RF Layout 3pi/2 for Discussion

RF Distribution – Neglecting Vacuum Support Platform

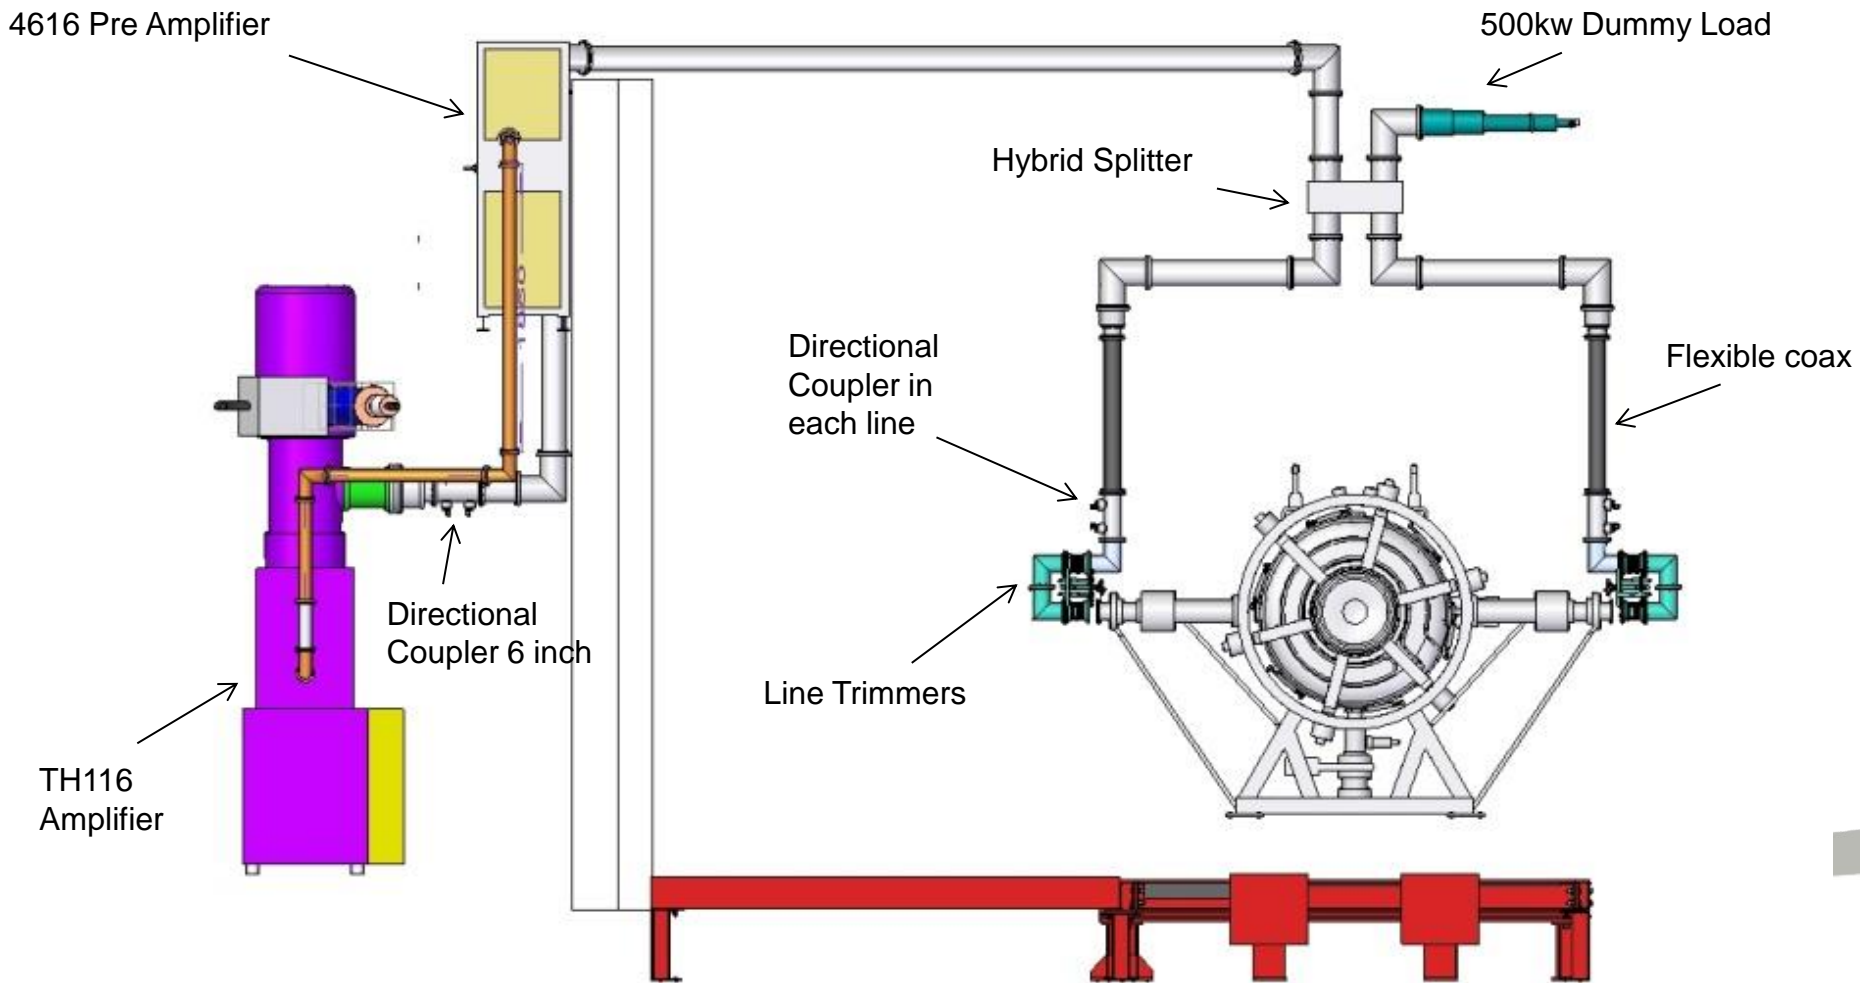
- Output line from amplifier is lower than the PRY, needs to go high to clear PRY to couple to South RF couplers
- Already have the 6" coax to go over the wall
- No advantage in going through the wall

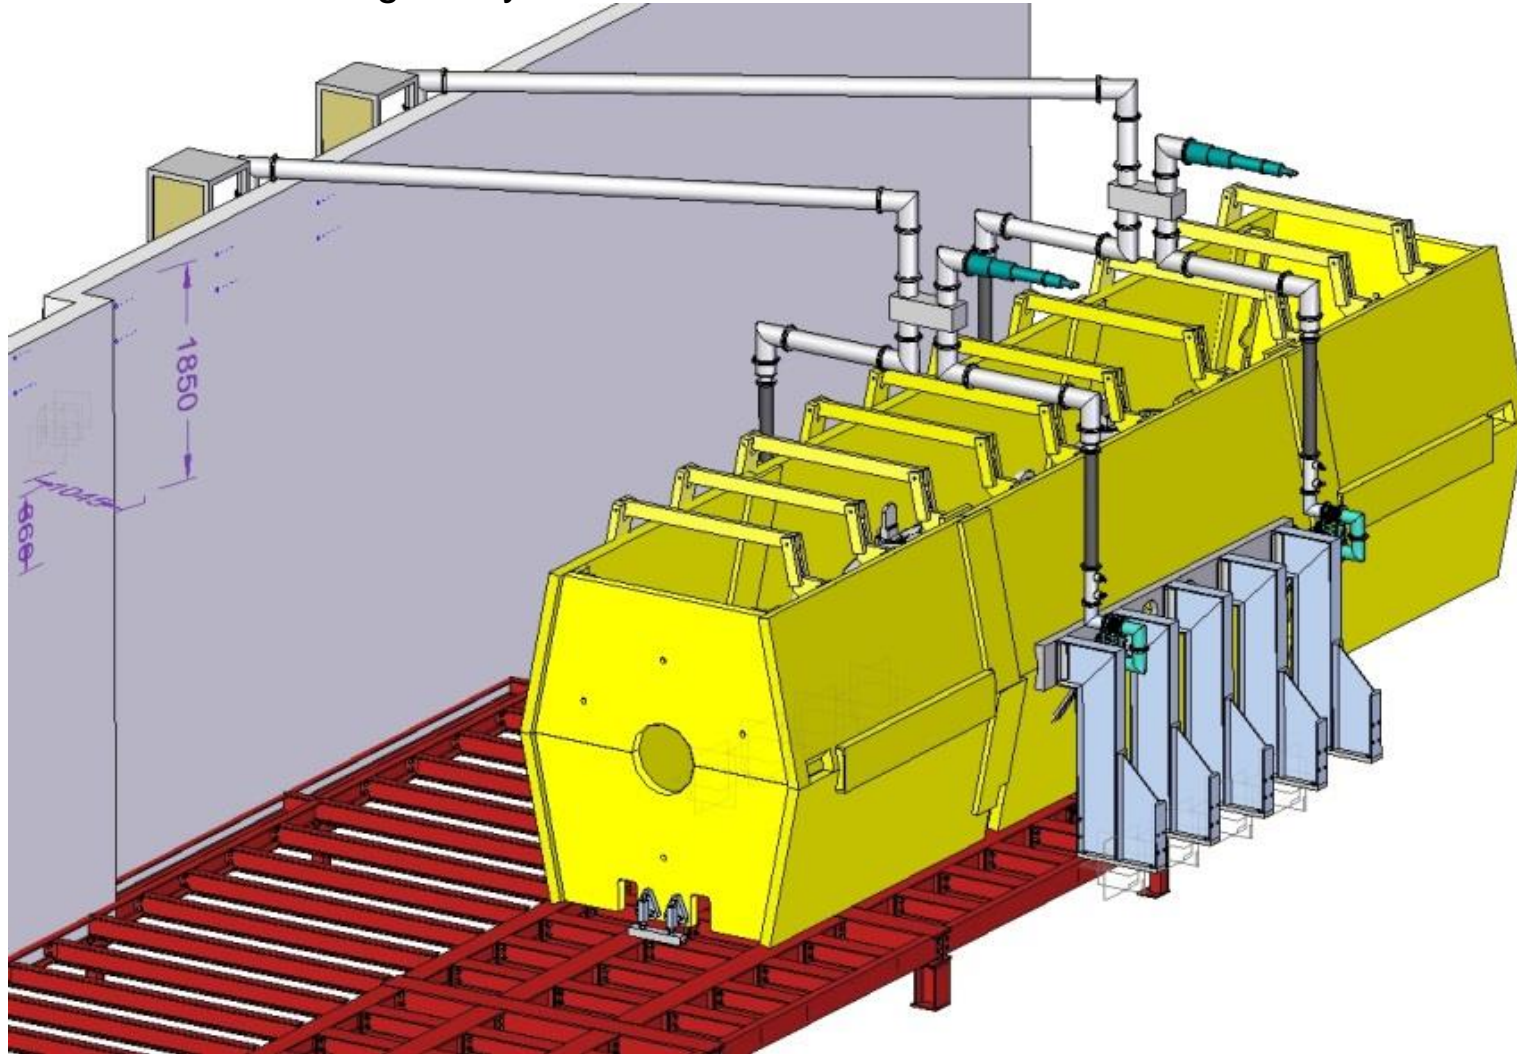
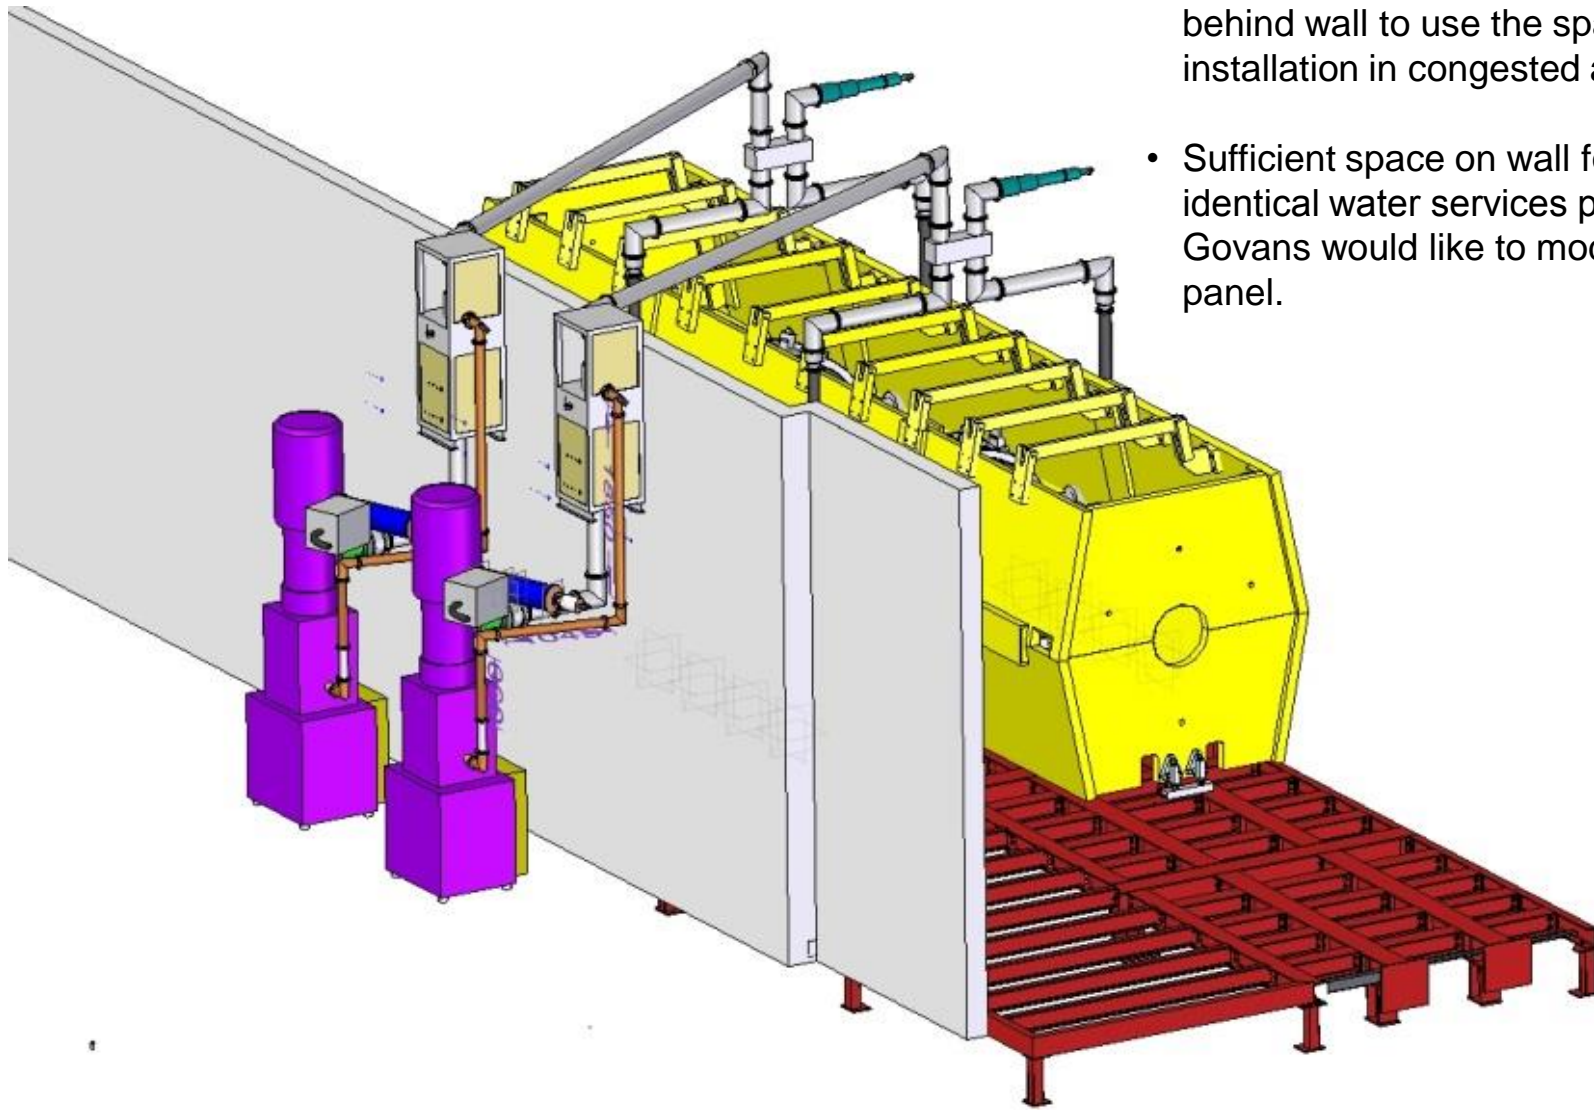
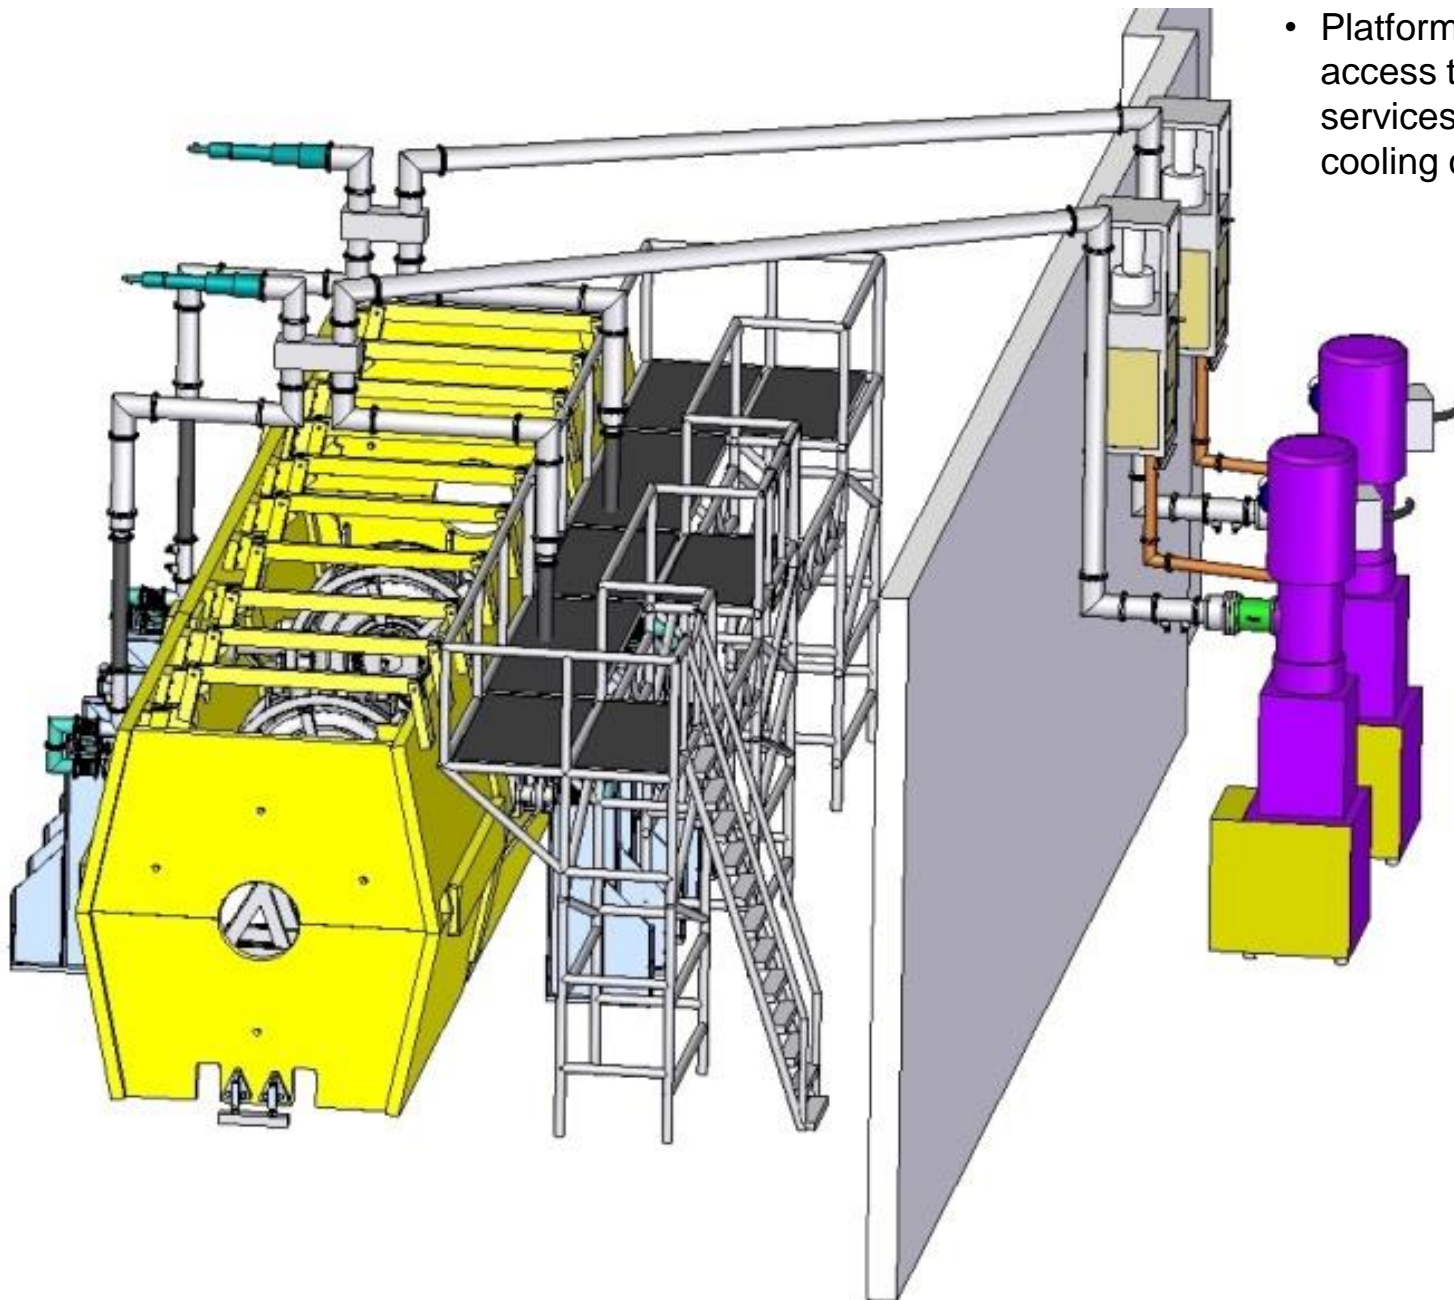
- MTA advised not to use ‘T’ splitters, suggested hybrid splitter was a far better solution as it isolated the cavity couplers from each other.
- Propose to have 1off dummy load on the hybrid splitter to each RF cavity.
- Crane hook height fully retracted does not clash with the coax over the wall.

- 2nd TH116 amplifier moved to 3rd position behind wall to use the space and ease installation in congested area
- Sufficient space on wall for additional identical water services panel.....John Govans would like to modify existing panel.

- Platform scaffolding reqd to gain access to equipment and services running on top of the cooling channel
